CITY OF West Linn

Subject: CUP-11-01/DR-11-06 Resubmittal

Conditional Use Permit and Design Review for an 1,344 SF Covered Parking Building

Existing Conditions Plan

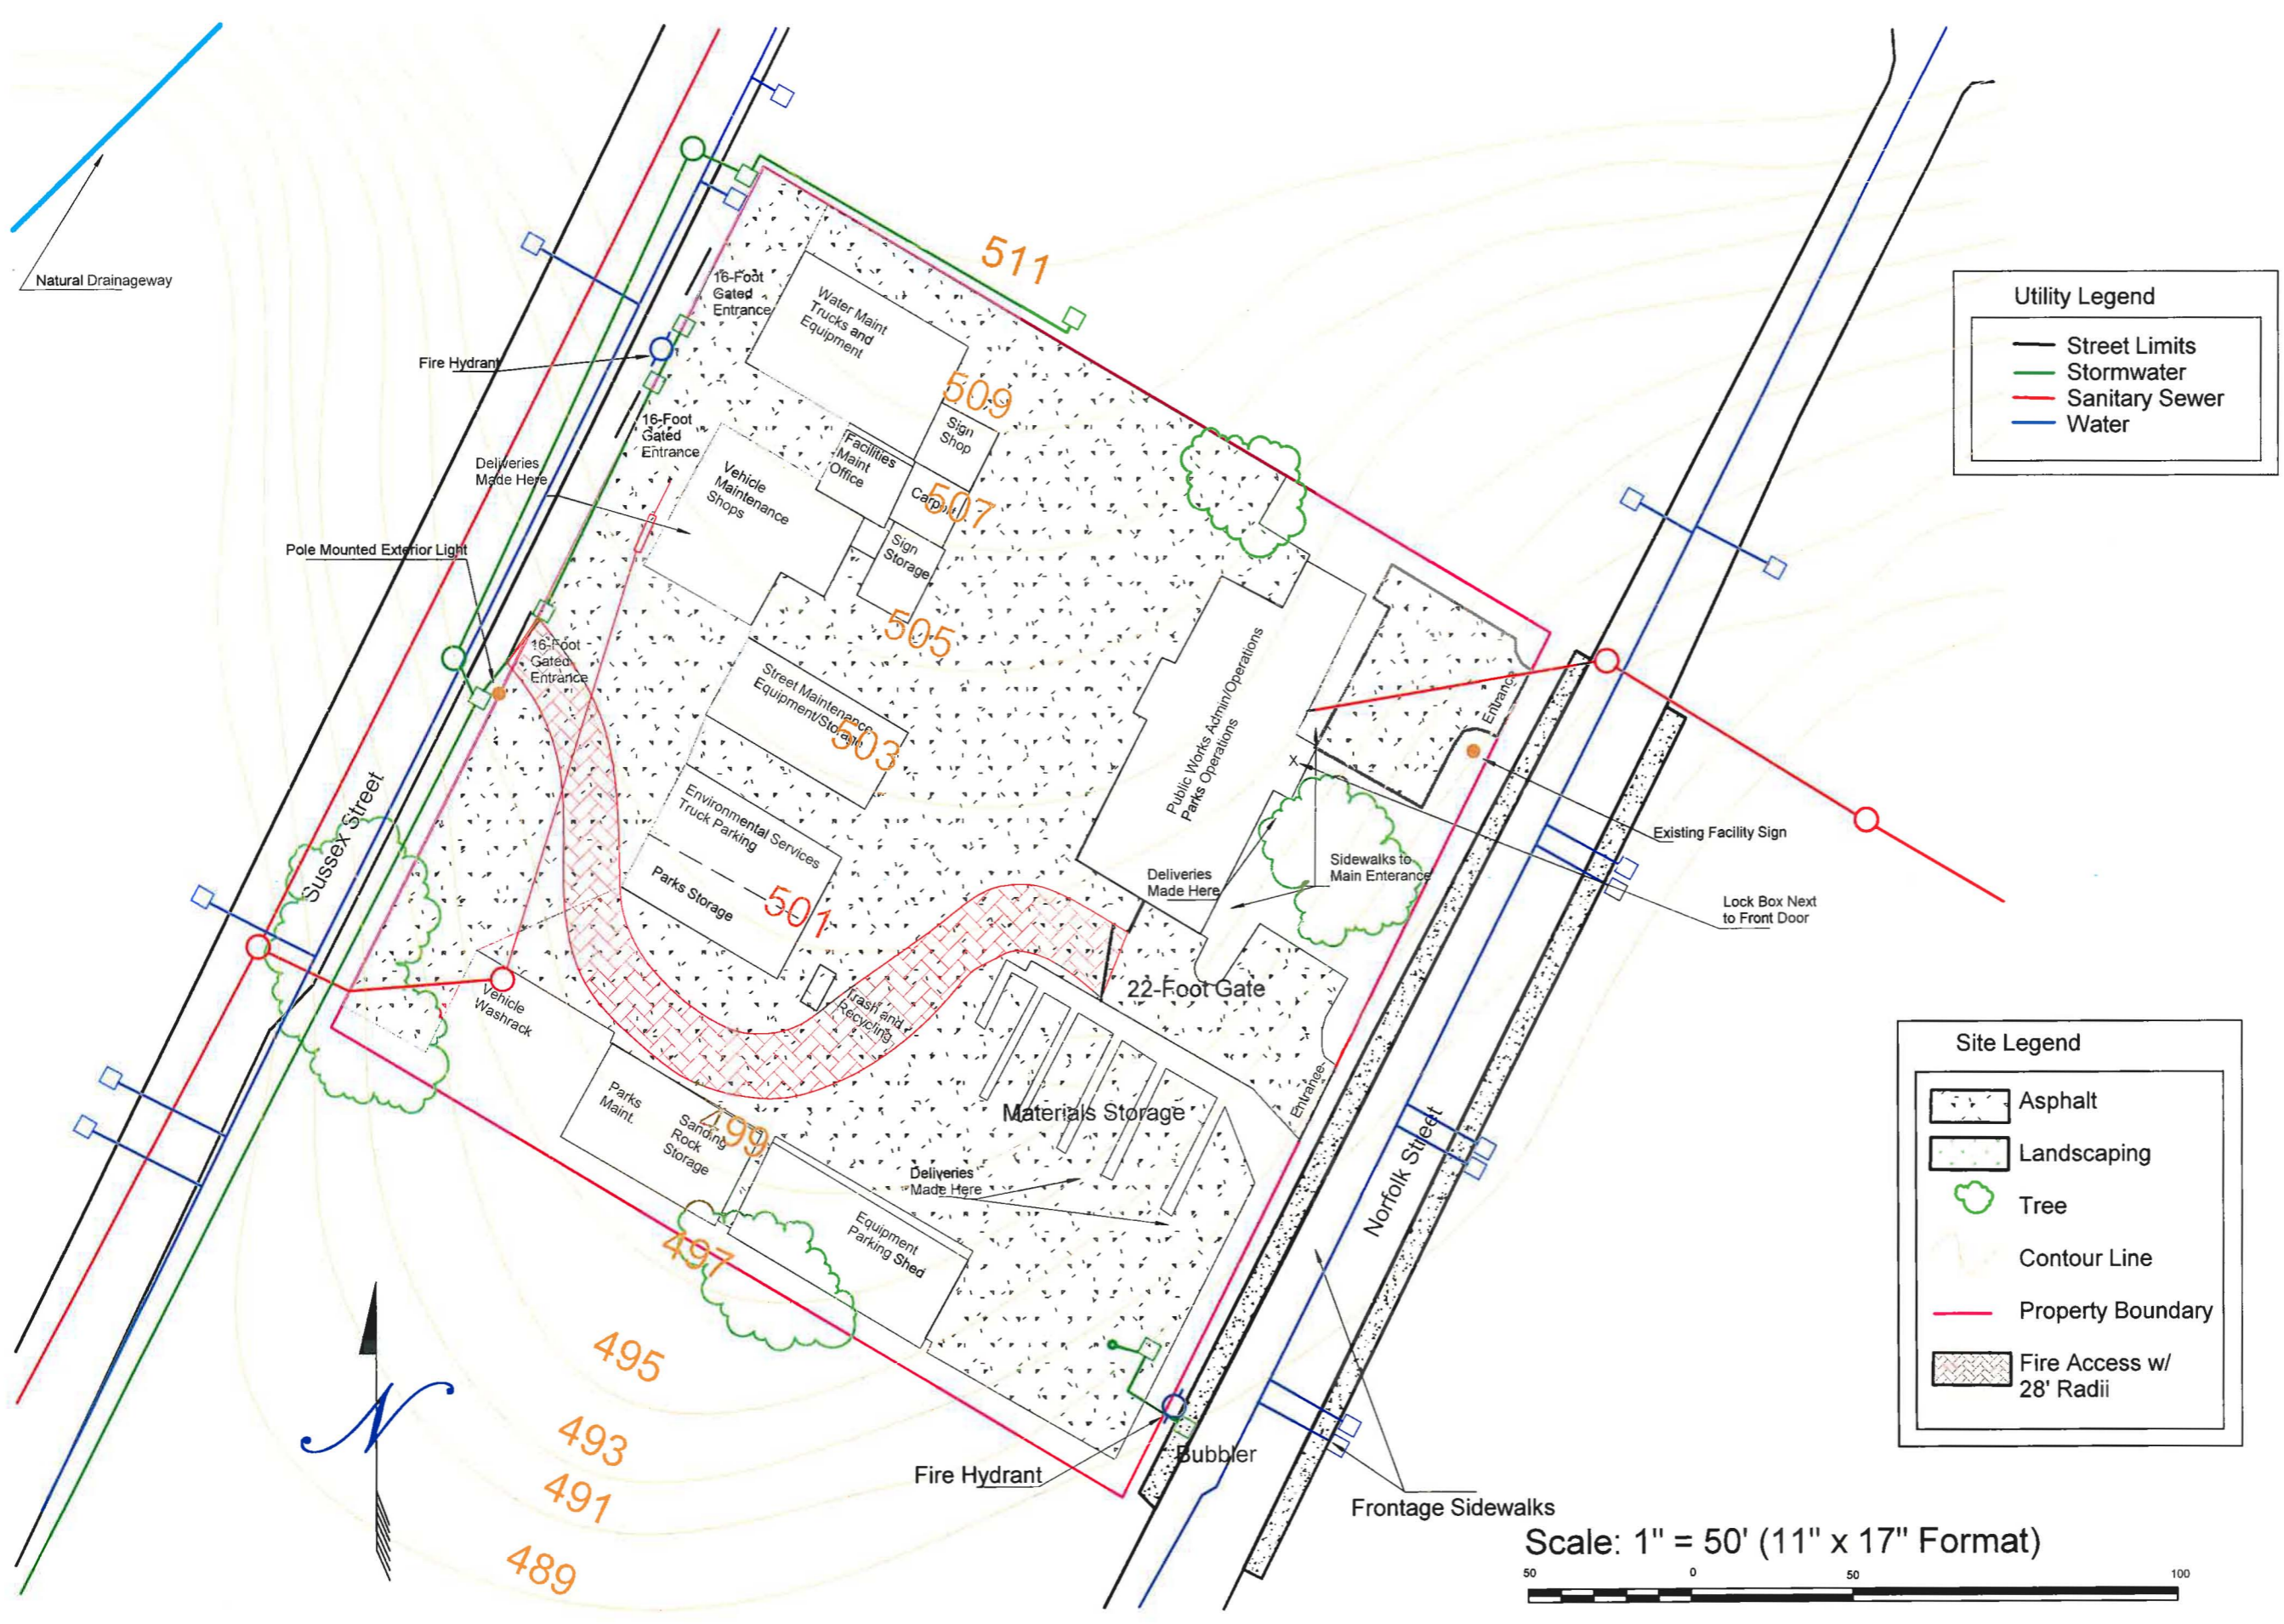
Sidewalk to main building has been shown the Existing Conditions plan. There is no bike parking.

Stream location has been included on the Existing Conditions plan as requested.

The sign location is shown on the Existing Conditions plan as requested.

After further clarification with you, you only seek pole mounted yard lighting. The site only contains one such light and its location has been included on the Existing Conditions plan as requested. All other exterior lighting on the site is building mounted.

Site and Adjacent Properties, Structures and Setbacks Plan

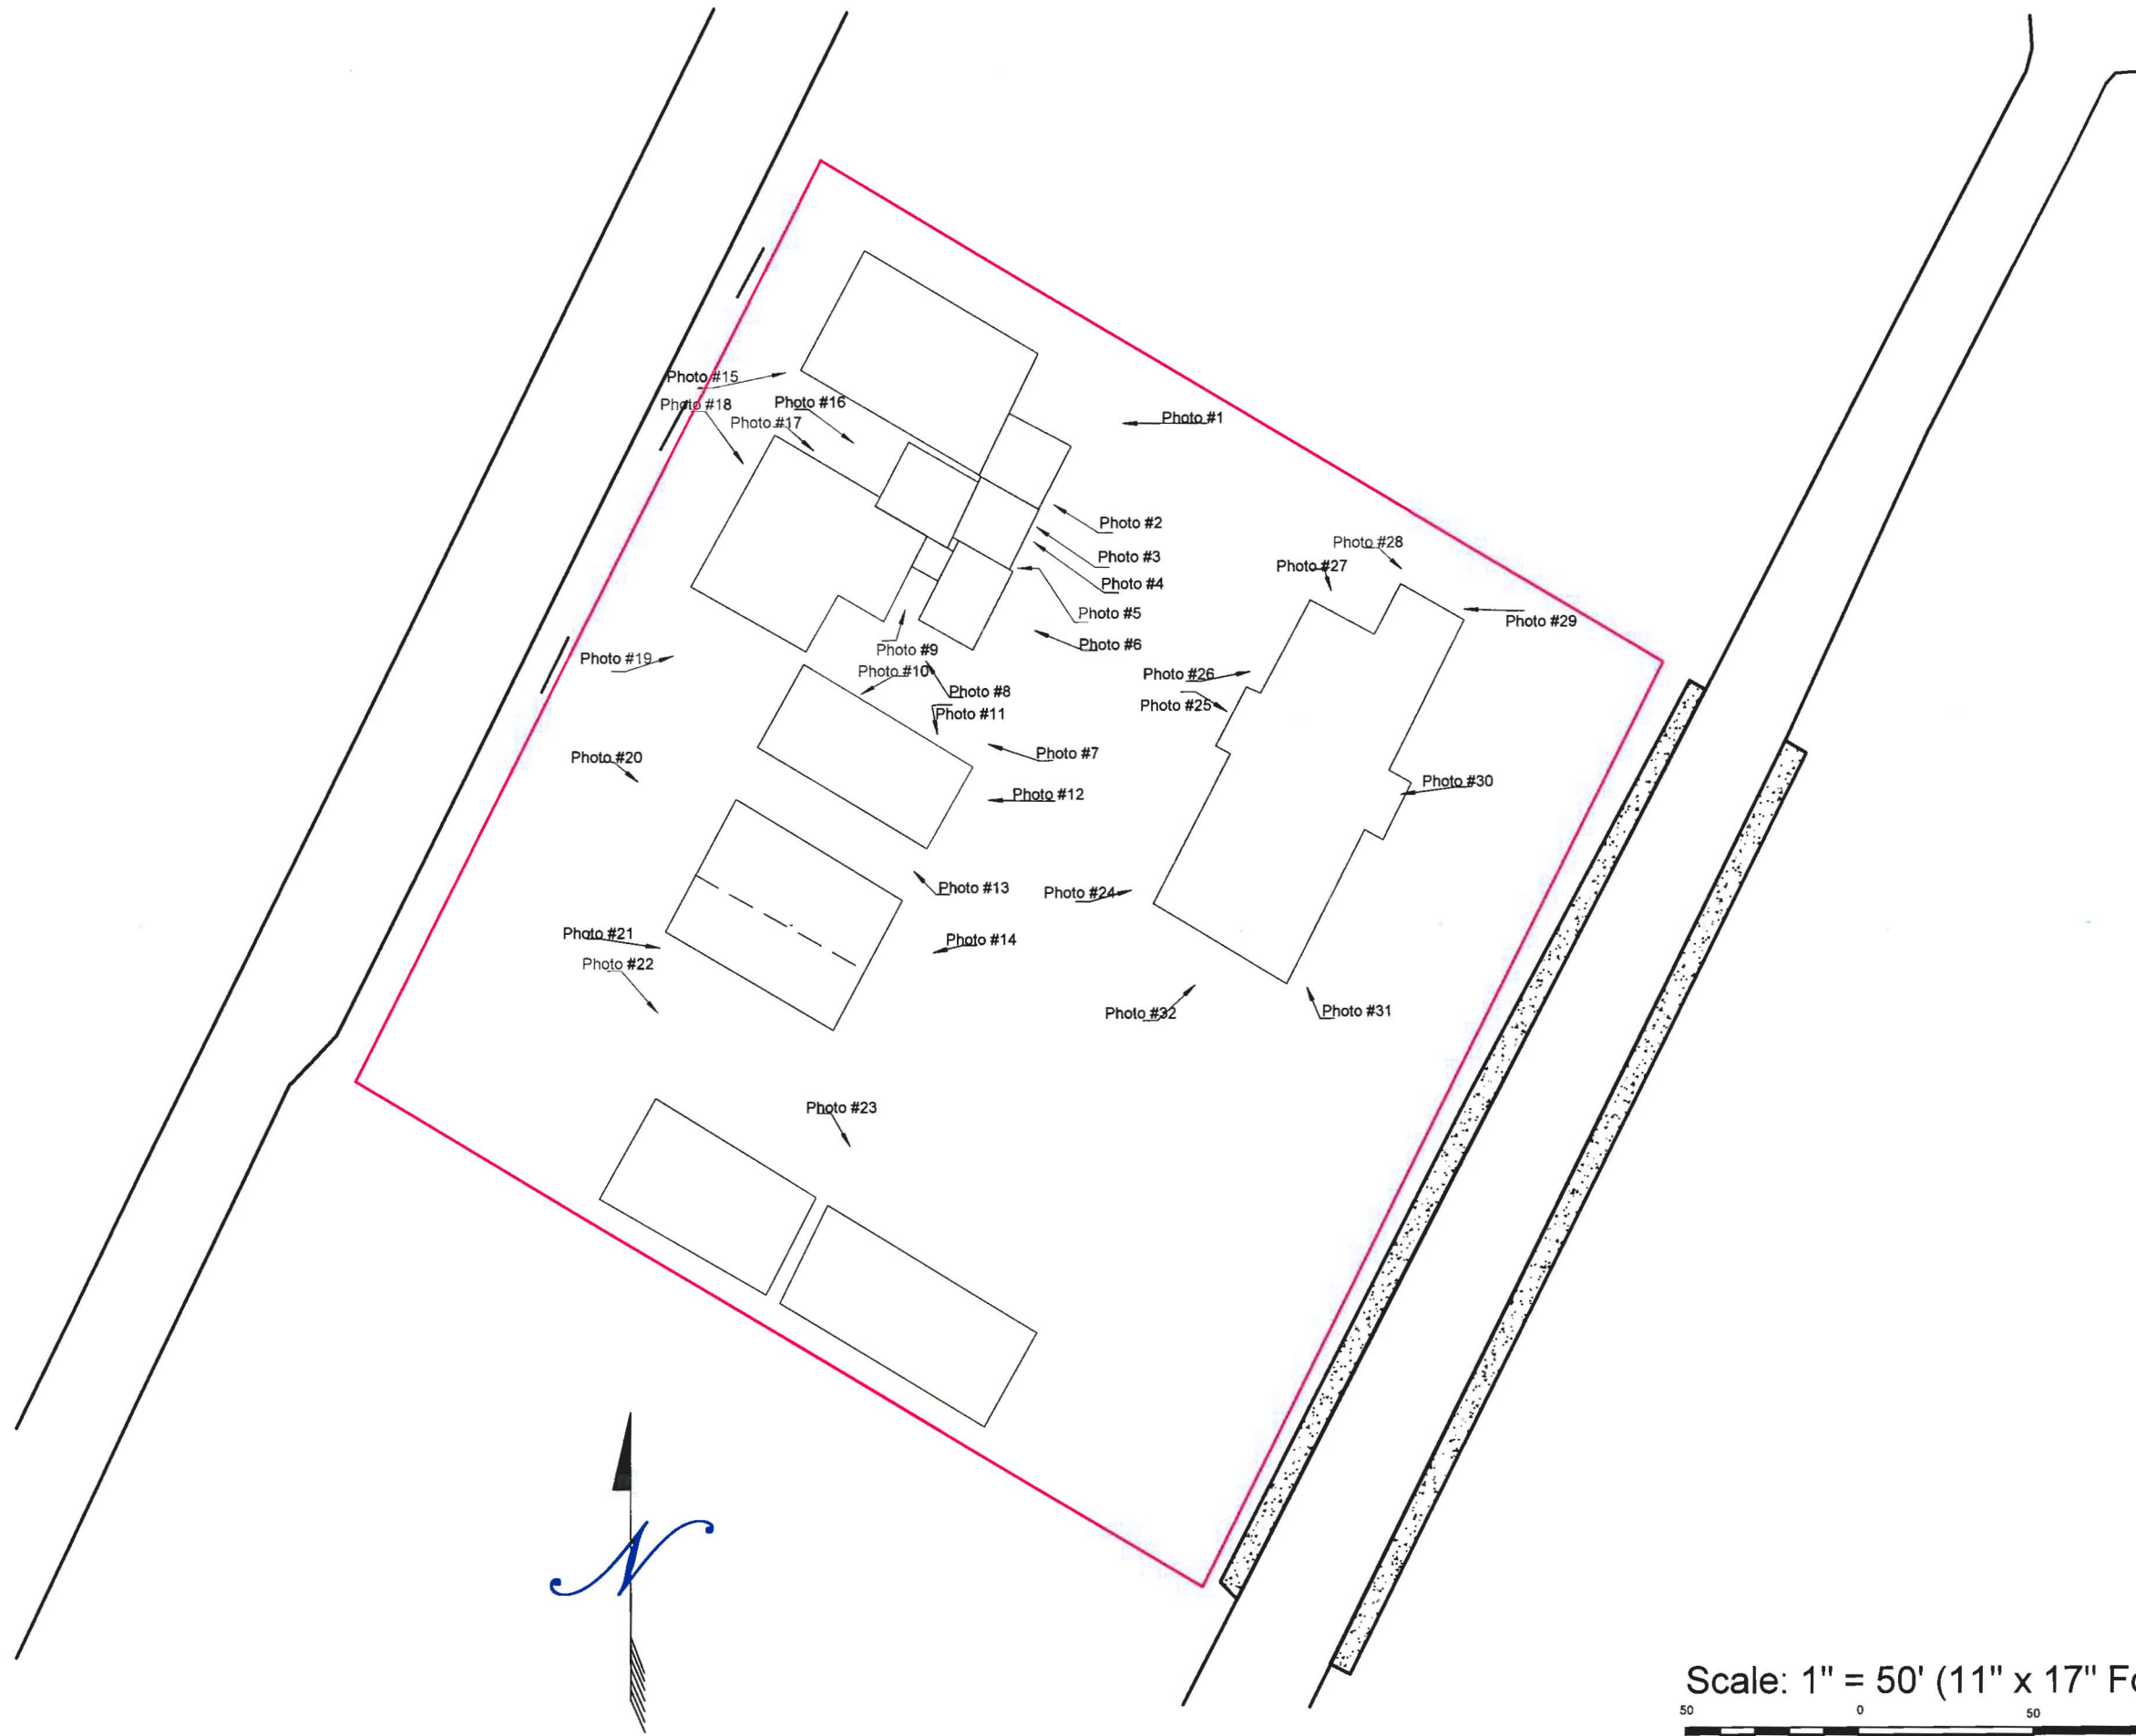
Show easements on surrounding property (and the lot lines). There are some easements on surrounding property per Snap Map.

Easements have been added to the Site and Adjacent Properties Structures and Setbacks plan.
